1963 Corvette: Service Bulletin: Interim Production Changes

Subject: Interim Production Changes
Model and Year: 1963 Corvette
Source: Chevrolet Technical Service Bulletin
Bulletin No: DR #569
Section: XV
Date: December 31, 1962

PARKING BRAKE LEVER ASSEMBLY REPLACEMENT

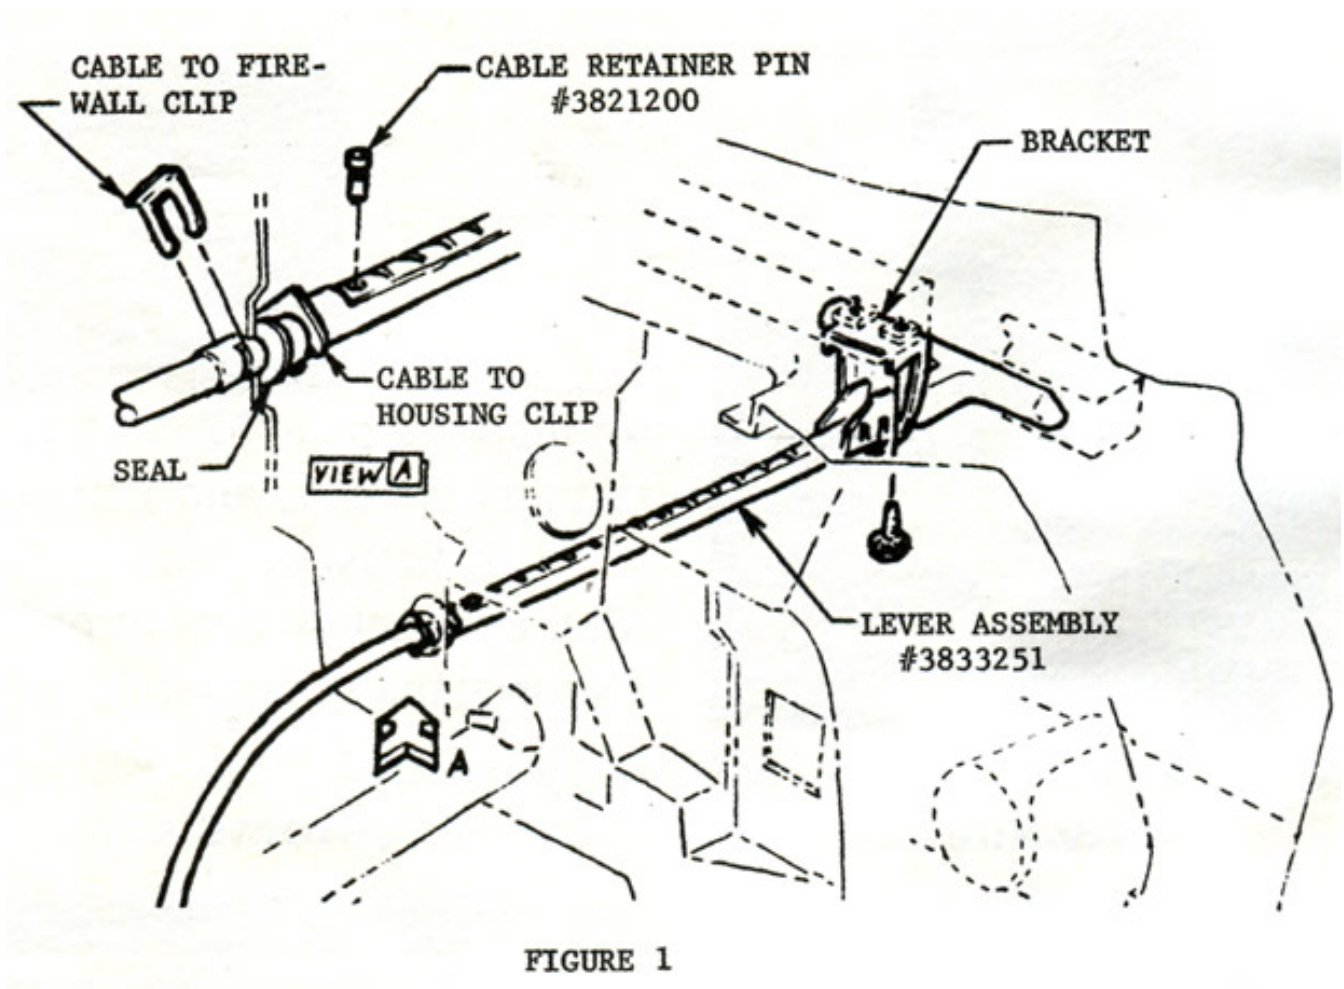
1. Effective with Serial No. S101893, a redesigned parking brake lever assembly entered Production. Early vehicles incorporate a lever assembly which may be difficult to release and in extreme cases, may actually jam making release impossible.
2. Vehicles with Serial No. S101847 through S102667, were built with a second design rear axle driveshaft flange that may not seat properly in the rear wheel drive spindle flange. An interference condition at this location could possibly lead to early failure of the rear wheel spindle flange attaching bolt bosses.

Lever Assembly should be replaced on all vehicles built prior to Serial No. S101893. Referring to Figure 1, proceed as follows:

1. Scrape sealer away from cable to firewall clip and remove clip.
2. Disconnect parking brake cable clip from steering gear retainer bolt.
3. Disconnect oil pressure line at gauge and pull line out of parking brake lever assembly bracket.
4. Remove two (2) bolts holding bracket to dash brace.
5. Pull complete lever and cable assembly to the rear, far enough to remove parking brake signal switch.
6. With handle all the way in, cable retainer pin will line up with hole in bottom of housing allowing pin to be driven out from bottom with a punch.
7. Remove cable to housing clip and separate cable from housing.
8. Install original seal on new lever assembly No. 3833251.
9. Reassemble by reversing the above steps using new cable retainer pin No. 3821200. NOTE: Chamfered side of pin must face forward to

actuate the parking brake signal switch properly.

10. Apply body sealer around cable at firewall to prevent water leaks.

FIGURE 2

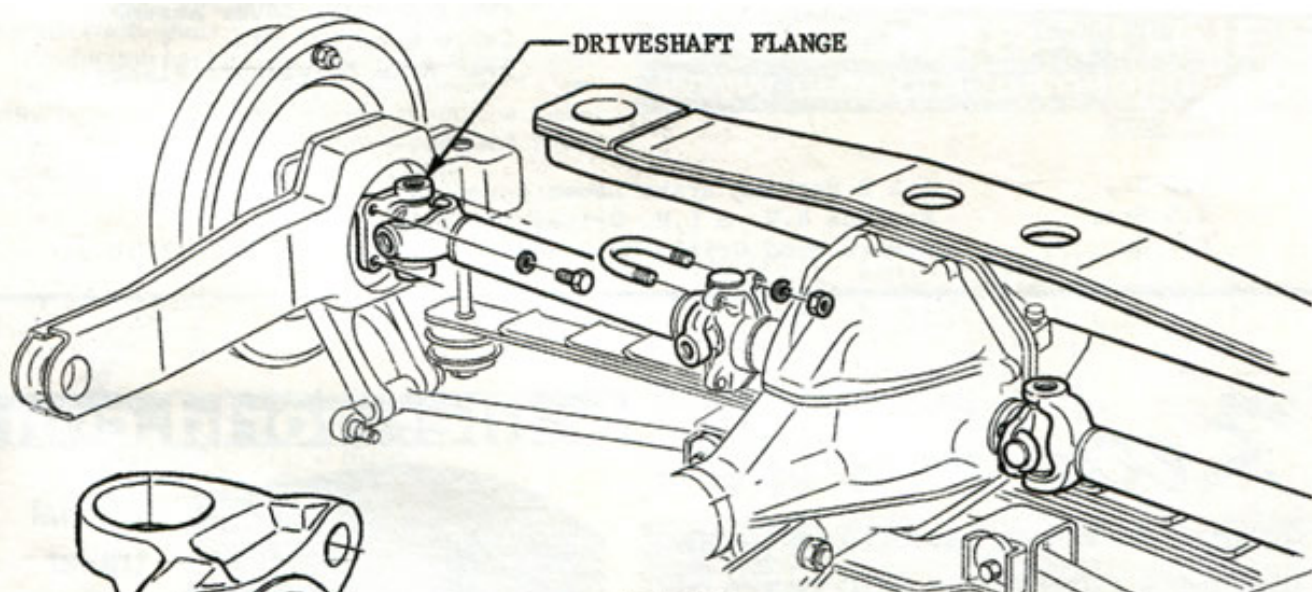
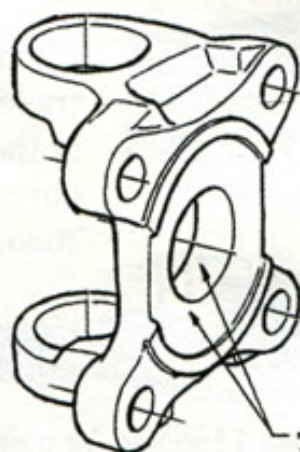
New machined Driveshaft Flanges No. 3832048, should be installed on all vehicles with Serial No. S101847 through S102667 (Ref. Figs. 2 and 3).

Replacement of the driveshaft flange is covered in the 1963 Corvette Shop Manual, Page 4-16. The rear wheel spindle flange attaching bolt bosses should be visually inspected while the axle driveshafts are out of the vehicle. Replace with new Spindle Flange Assembly No. 3830253 if any cracks are evident in the area indicated in Figure 4.

FIGURE 3 - DRIVESHAFT FLANGE

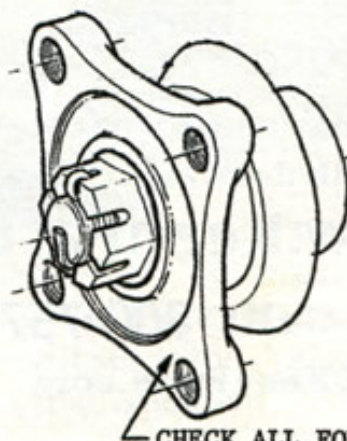
Vehicles built after S102667 incorporate selective fit pieces or additional machining to insure adequate clearance.

THESE SURFACES
MACHINED FOR
CLEARANCE
